**PROPOSAL: PROPOSED LOFT
CONVERSION WITH GABLE / REAR
FLAT ROOF DORMER; FORMING
BEDROOM.**

**MR R FISHER.
9 CHURCH LANE,
MIRFIELD.
WF14 9HU.**

EXISTING ROOF PLAN.

PAPER	SCALE	DATE	DRAWING No	REV
A3	1:50	10/25	M4632/01/104	A

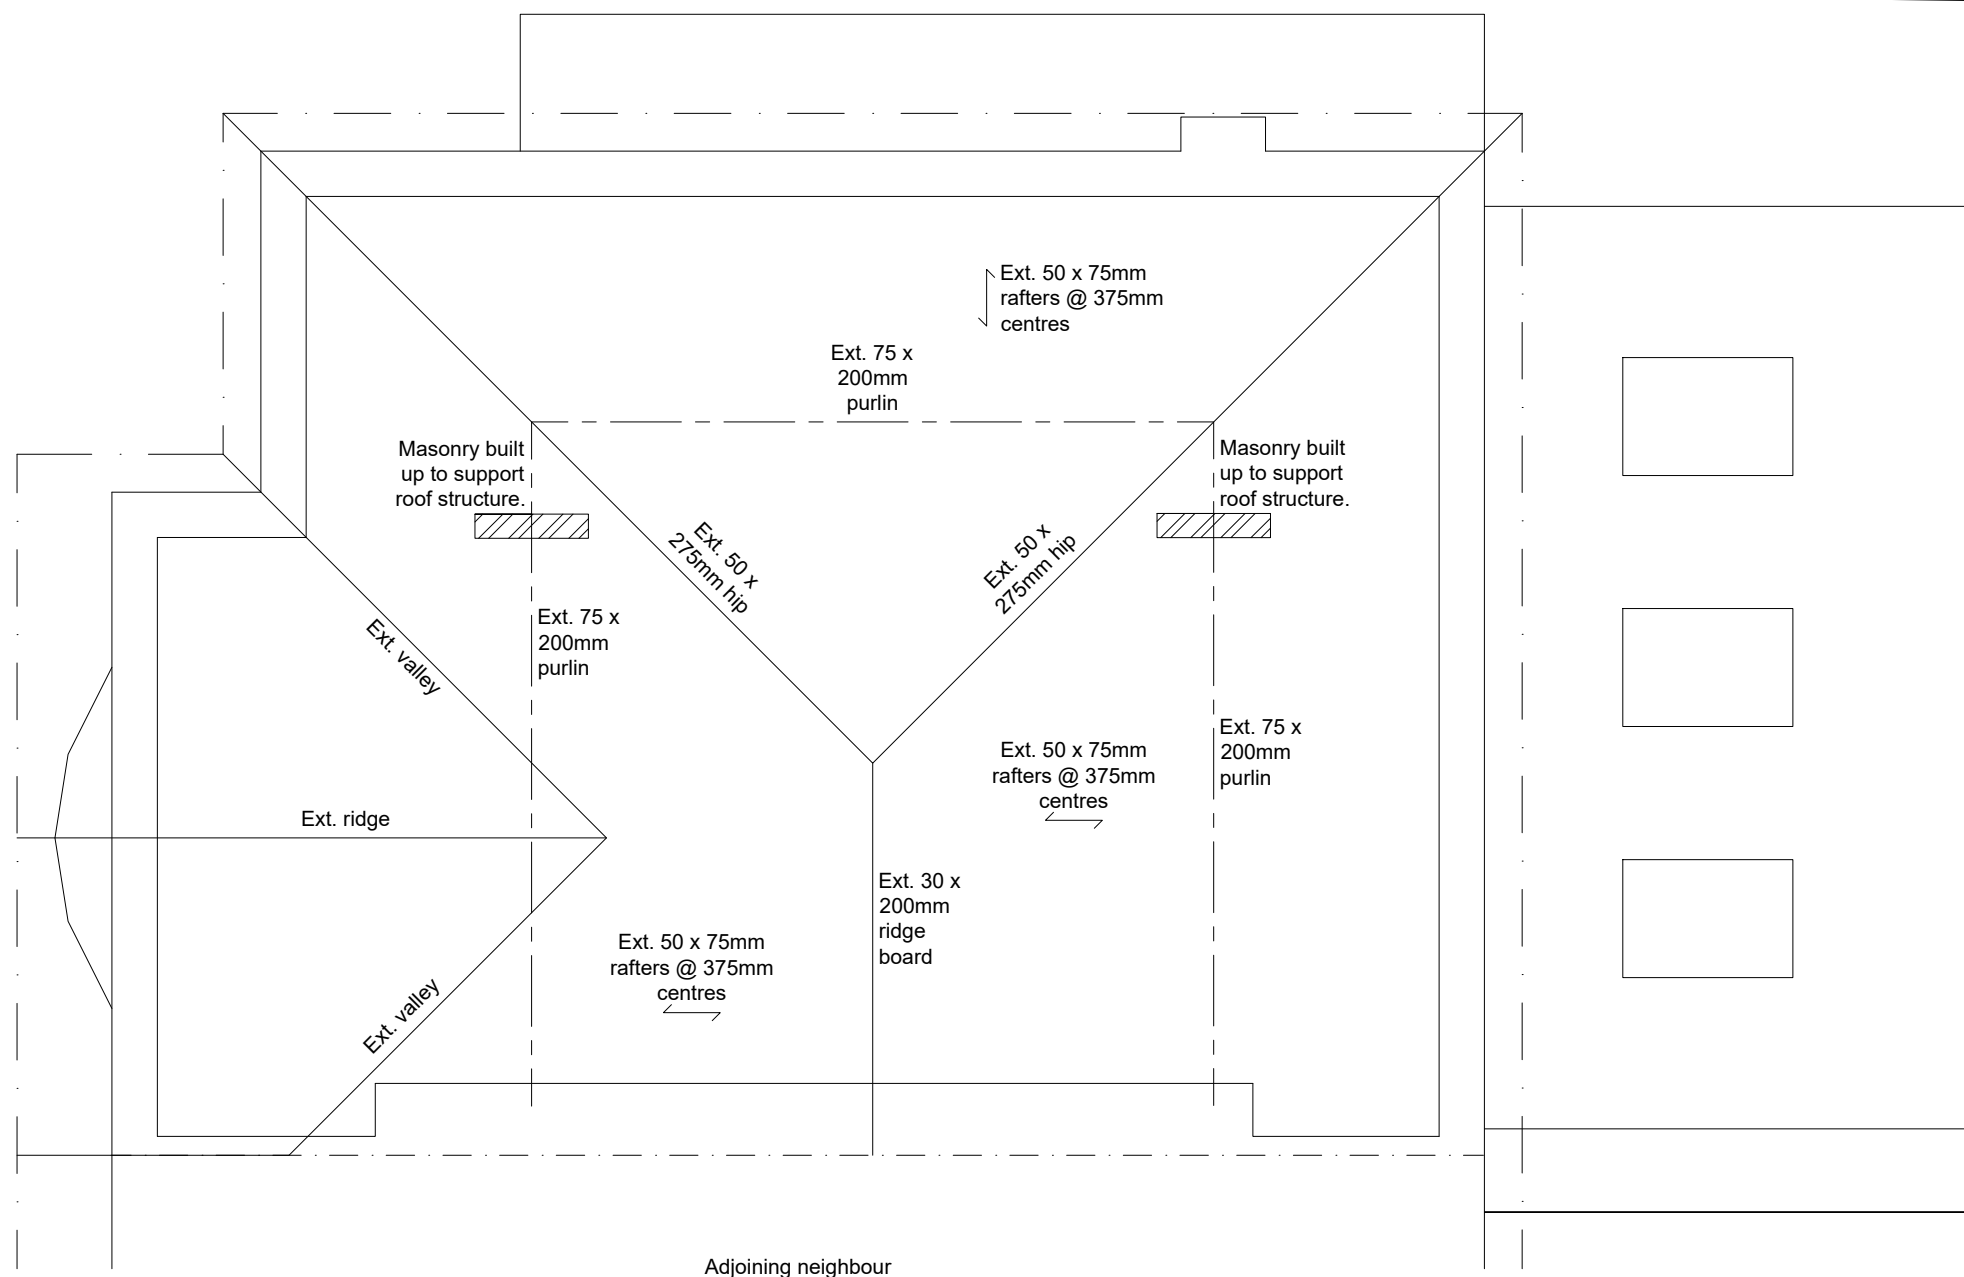
Rev.A Reverted new S&VP to ext. S&VP to suit Planning Officers comments. 23.03.26
